LANDSCAPE AND VISUAL REBUTTAL

**OF BRIAN JOHN DENNEY BA (HONS), DIPLA, FLI, CENV,
MIEMA**

**AN OUTLINE PLANNING APPLICATION FOR THE
ERECTION OF UP TO 85 RESIDENTIAL DWELLINGS
(*REDUCED FROM 93 ORIGINALLY*) AND OPEN SPACE
(17/04673/OUT)**

**LAND AT JUNCTION WITH CARR ROAD, HOLLIN BUSK
LANE, SHEFFIELD, S36 1GH**

ANNEX 3

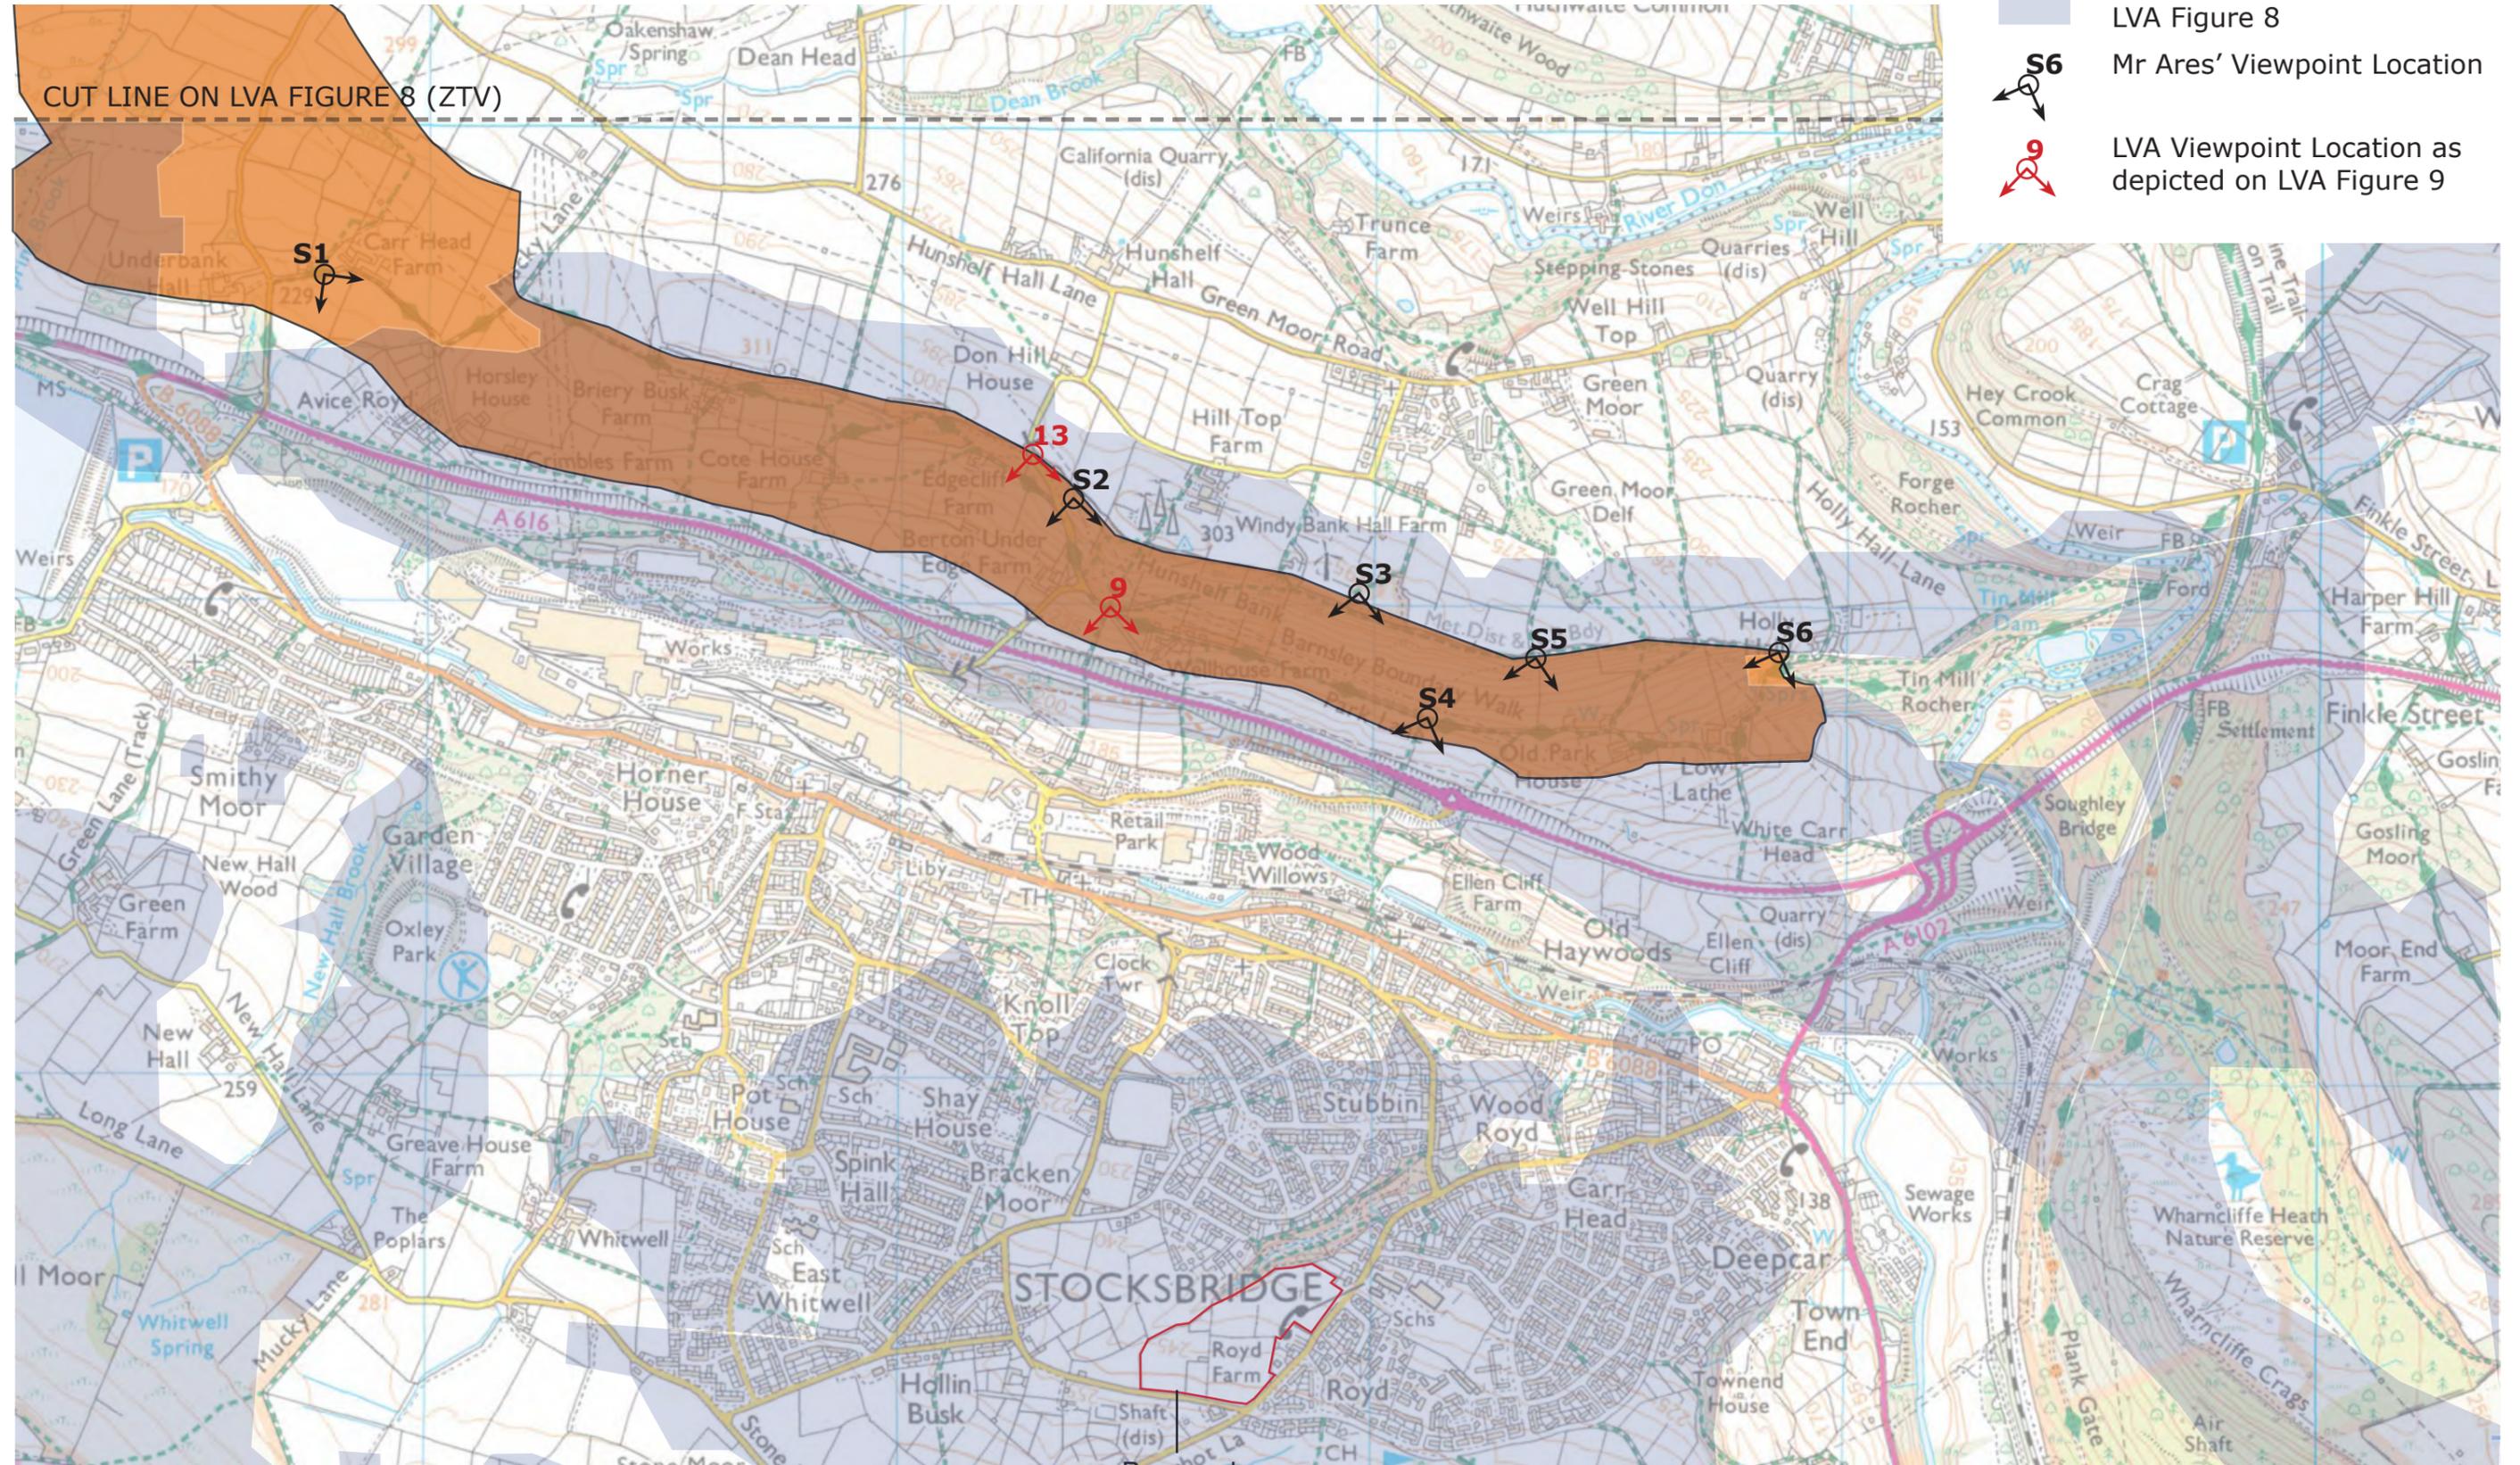
6. I provide at my Annex 3, an overlay of Mr Ares' ARVE. This overlay includes the extent of the areas of theoretical visibility as depicted within Figure 8 of the LVA. This clearly depicts that a considerable part of the landscape indicated by Mr Ares, as having clear visibility of the site, lies outside the ZTV. This may relate to the incorrect identification of the site location from Mr Ares viewpoint location S1.

7. My version of the ARVE plan also includes the locations of Mr Ares' remaining five viewpoints alongside those assessed within the LVA. This shows that all of these locations are broadly within the same landscape and at similar distances from the site (between approximately 1.18 km and 1.8 km) and have been assessed in the LVA and were considered by the Council's officers when the two recommendations to approve were drawn up.

Below is Mr Ares' Amended Representative Visual Envelope plan, upon which I have overlaid the areas within the ZTV taken from Figure 8 of the LVA. I also add Mr Ares' six additional viewpoint locations and the two representative viewpoint locations on Hunshelf Bank within the LVA.
